CC3 Chapter 9, UHS Update

March 18, 2013

**Public Meeting regarding issues related to
Ultimate Heat Sink System at
Calvert Cliffs Nuclear Power Plant Unit 3**

NRC/UniStar
Calvert Cliffs Unit 3
Public Meeting – March 18, 2013
Staff's Feedback
on the
Ultimate Heat Sink RAI Responses
(FSAR Section 9.2.5)

Preliminary Tracer Particle Results

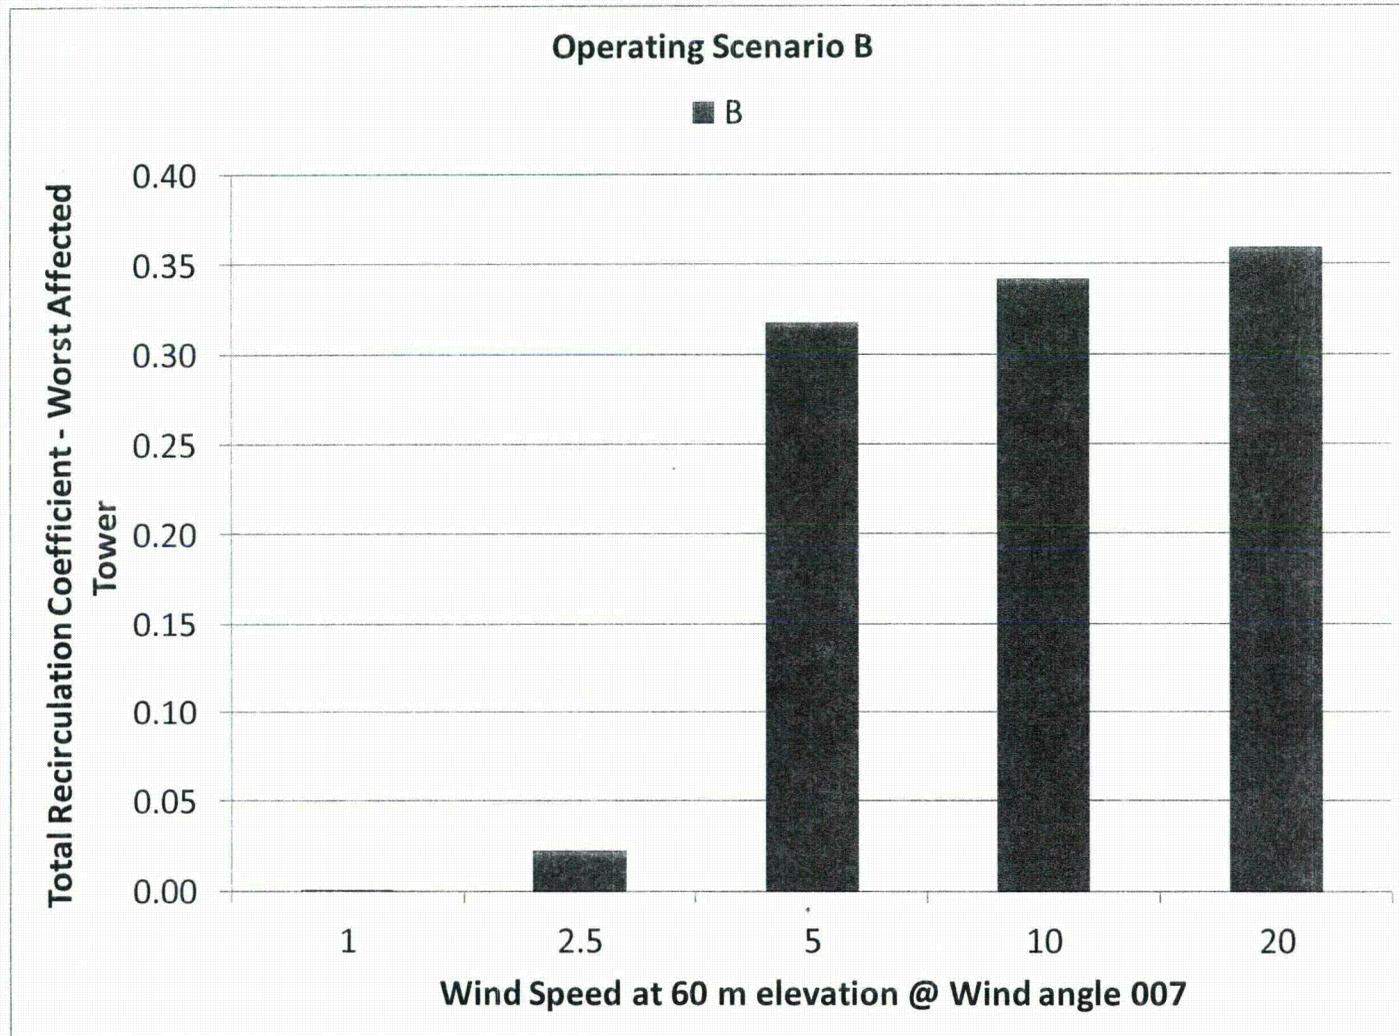
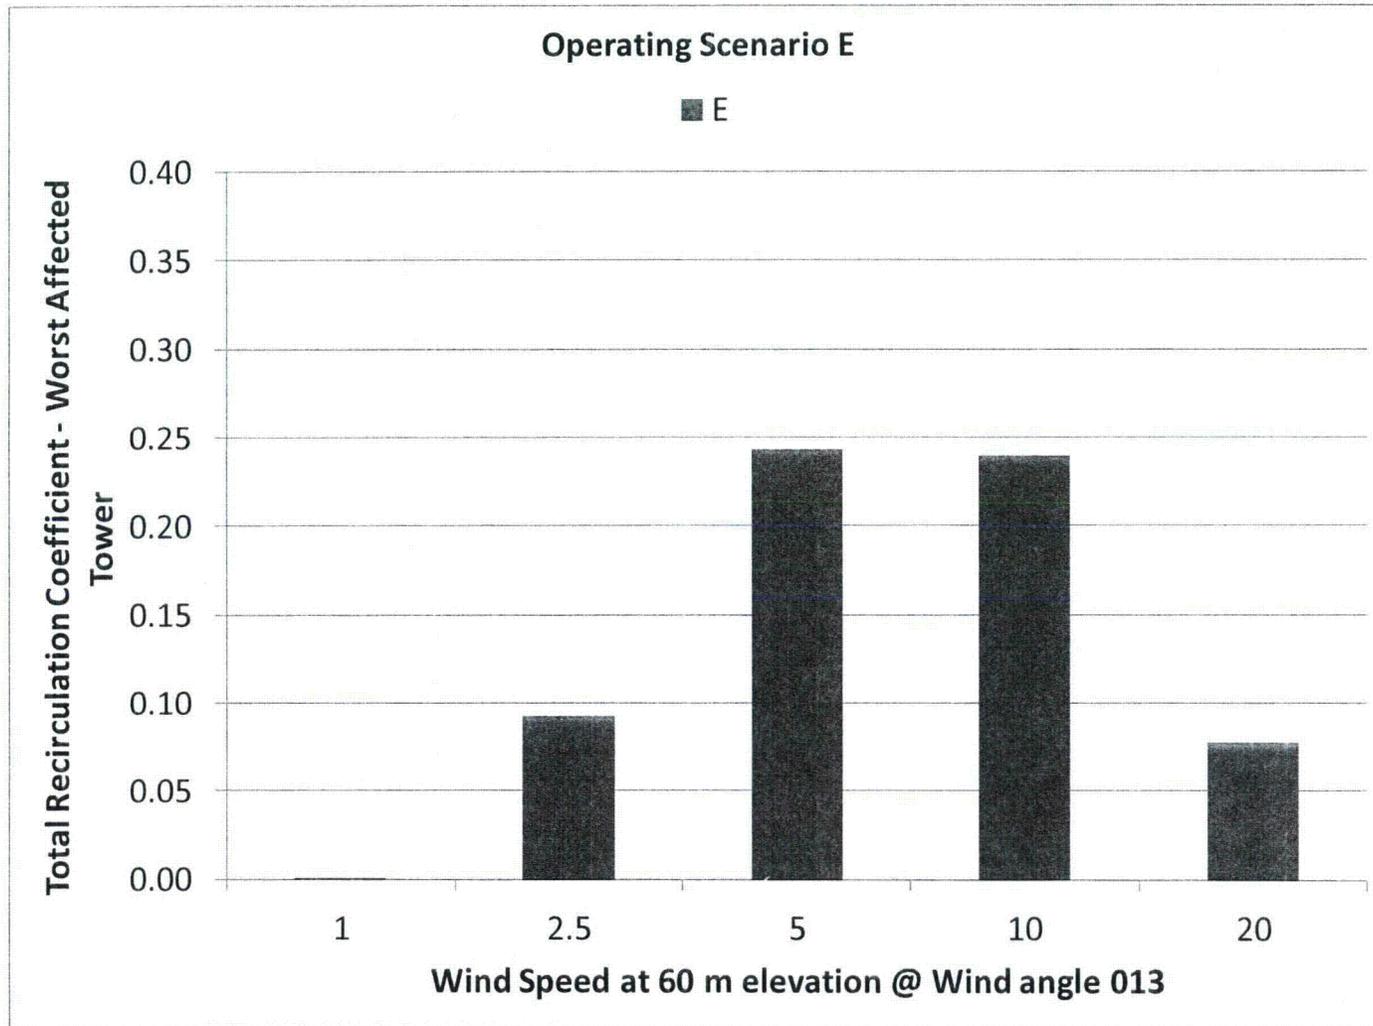
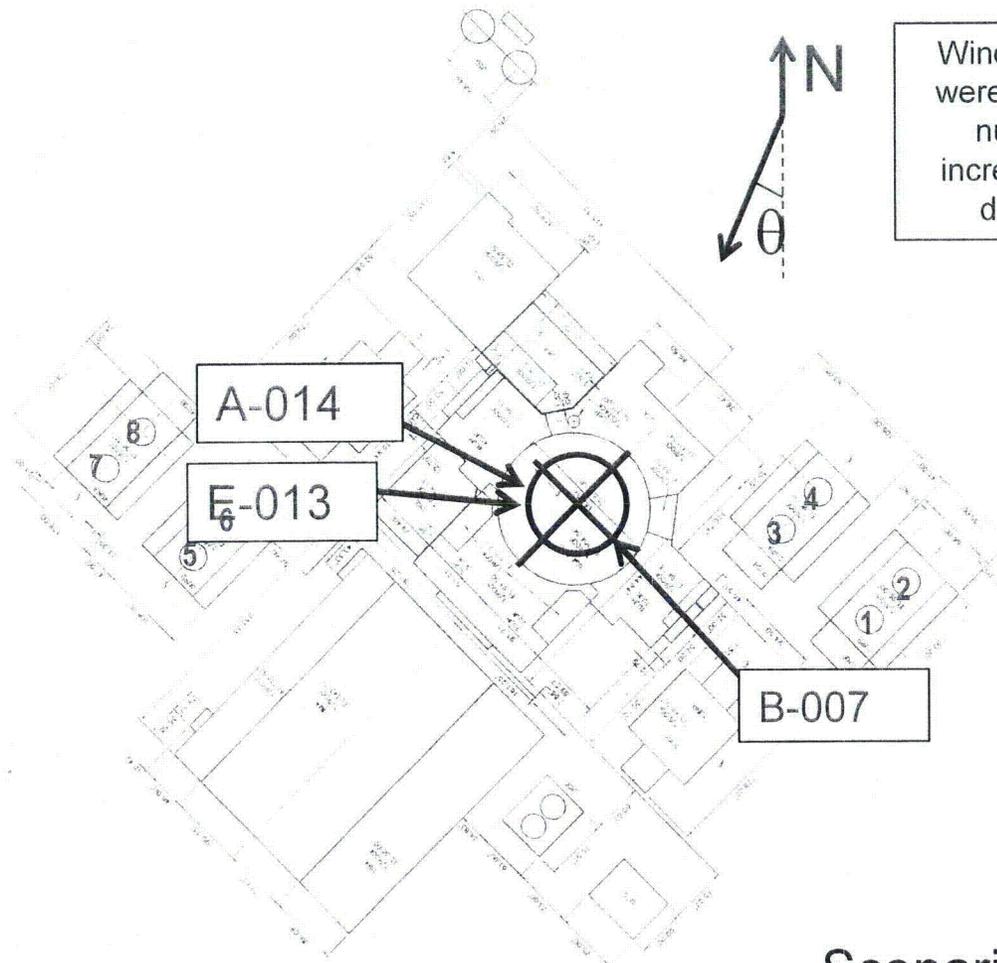
- Calculate approximate ingestion temperatures for wind speed 5 m/s for all scenarios and target scenarios with greater than 2.5°F interference.
- Perform sensitivity studies on wind speeds to identify worst speed for targeted scenarios.
- Select cases with highest ingestion temperatures for CFD analysis.

Scenarios B-007, E-013 and A-014 selected for CFD

Preliminary Tracer Particle Results B-007 @ 10 m/s

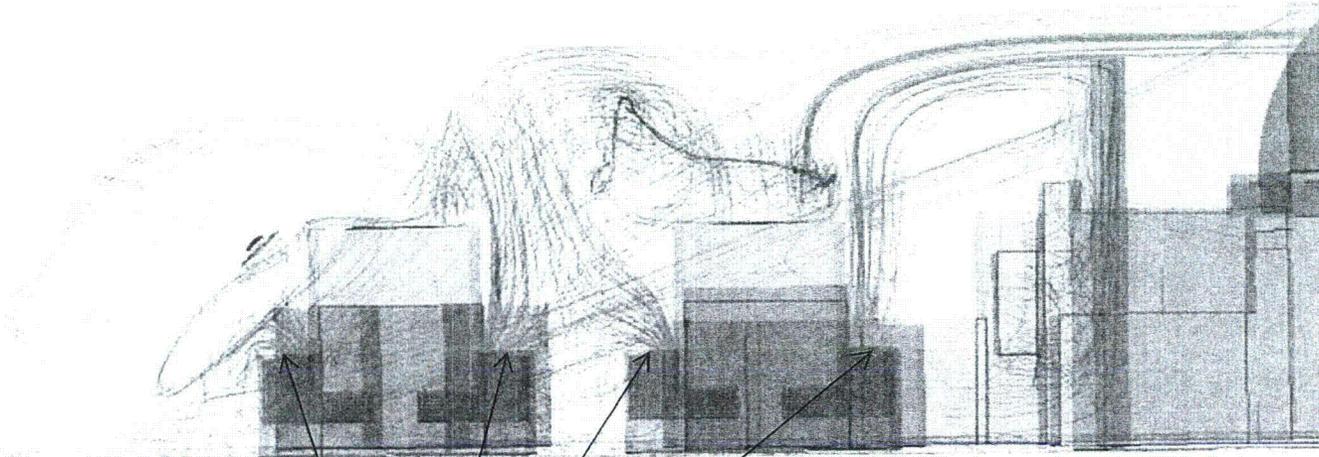
Tower intakes
